NEW MEXICO ENERGY, MINERALS and NATURAL RESOURCES DEPARTMENT

Re: OCD Permit No. SWD-782-A

While conducting a follow-up review of the permitting process for the Trading Post Disposal Well No. 1 (API No. 30-045-21470) located 950 feet from the North line and 1600 feet from the West line (Unit C) of Section 26, Township 25 North, Range 11 West, NMPM, San Juan County, New Mexico, it was determined that certain area of review well data required by Form C-108 was not submitted, and that the Division failed to contact you about this issue prior to approving the amended permit. Item No. VI of Form C-108 requires that:

**MARALEX DISPOSAL, LLC
CANYON NO. 14
PROPOSED PRODUCED WATER DISPOSAL WELL**

Maralex Disposal, LLC. San Juan County, N.M. Canyon #14 Permit

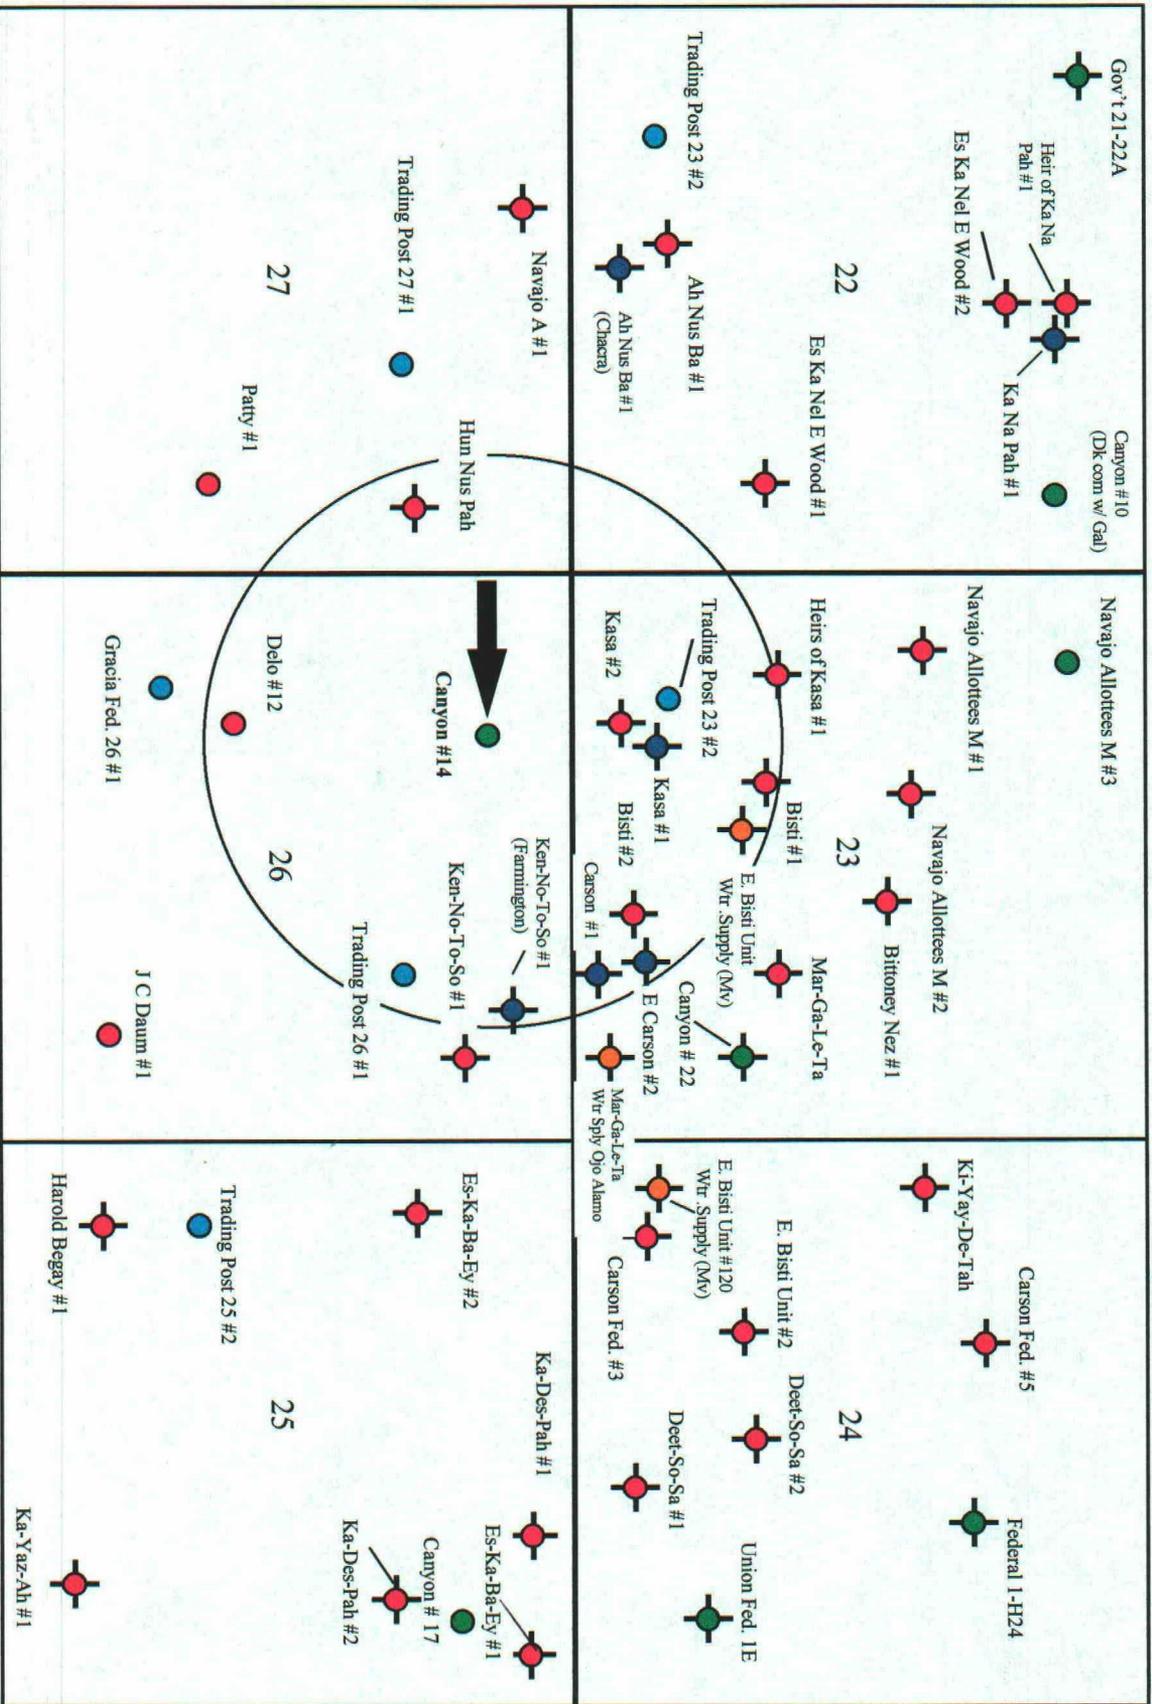
It appears that there are Gallup and/or Mesaverde wells within the area of review in which no well data was submitted.

Please provide this office with all well data as required by Form C-108 within 30-days from receipt of this letter.
